CITY OF KENORA

**TENDER #313-001-25
2026 City of Kenora Municipal Paving Program**

ADDENDUM No. 2

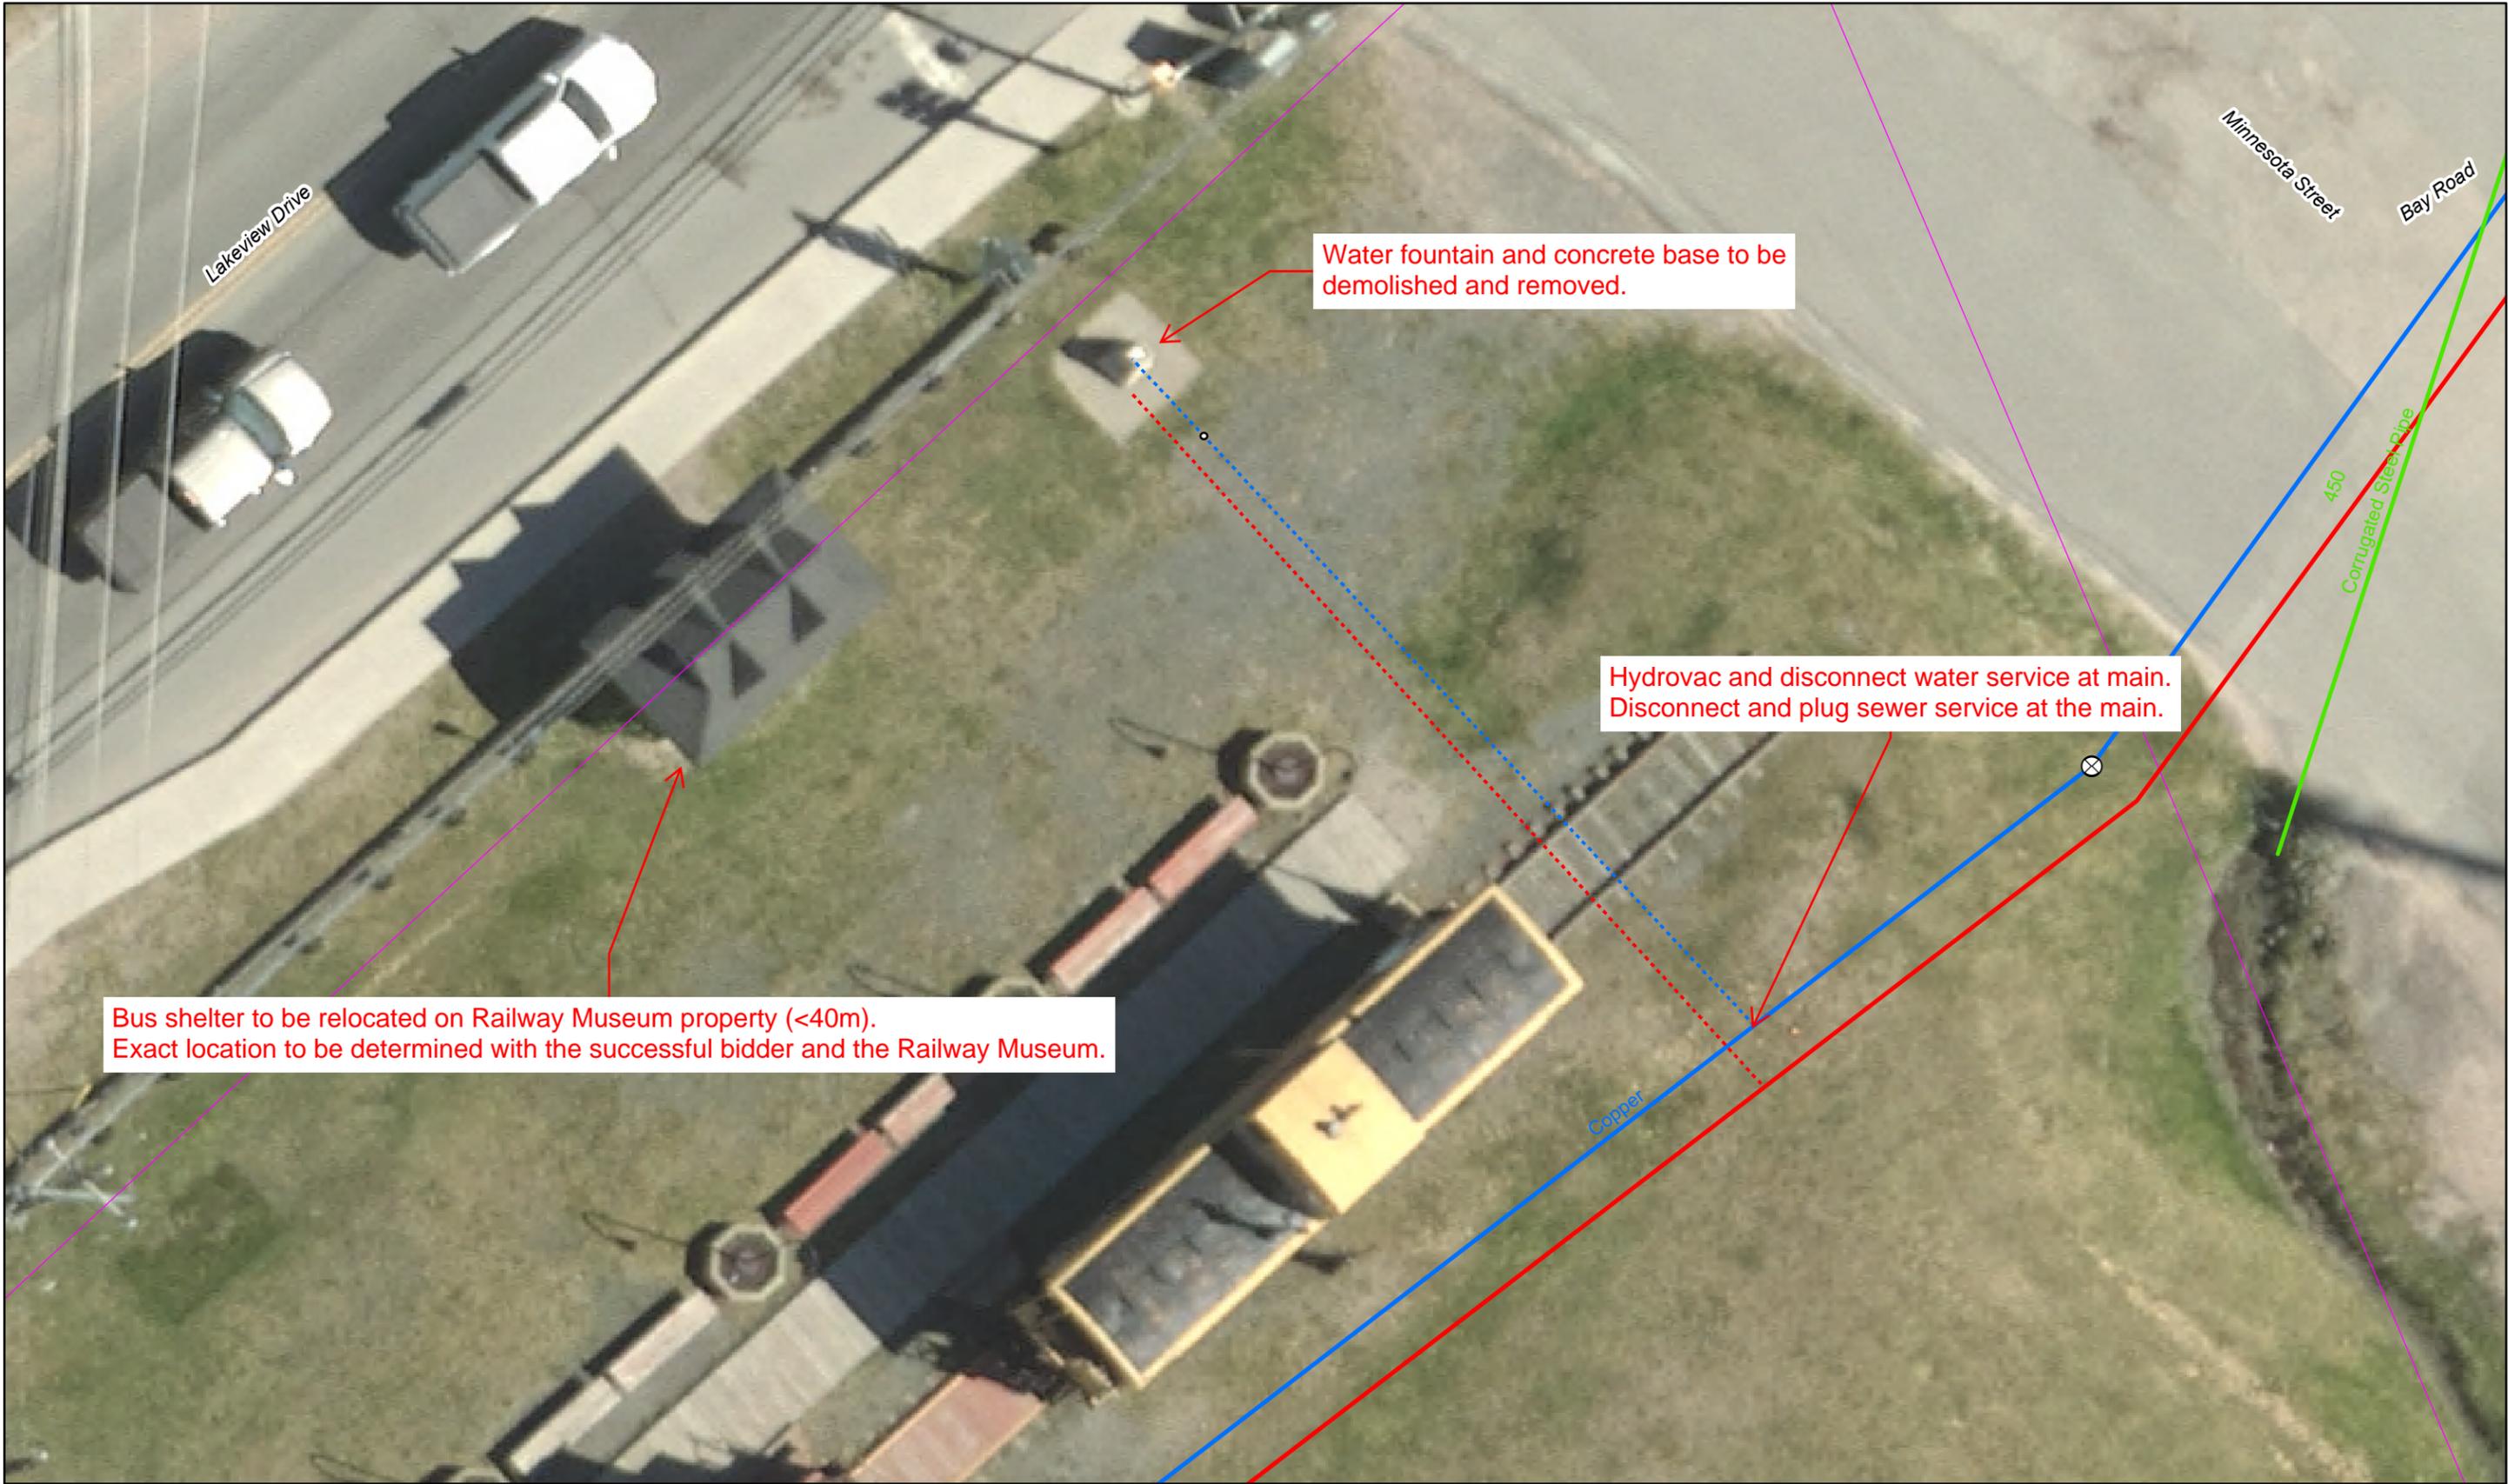
Water fountain and concrete base to be demolished and removed.

Hydrovac and disconnect water service at main.
Disconnect and plug sewer service at the main.

Bus shelter to be relocated on Railway Museum property (<40m).
Exact location to be determined with the successful bidder and the Railway Museum.

Section 1.29 Removal of Water Fountain

This Special Provision covers the demolition and removal of the existing water fountain at the southwest corner of the intersection of Lakeview Drive and Parsons Street, including demolition and removal of the existing concrete base.

- Disconnection of existing water and sewer services,
- Demolition and removal of the existing water fountain;
- Demolition and removal of the existing concrete base;
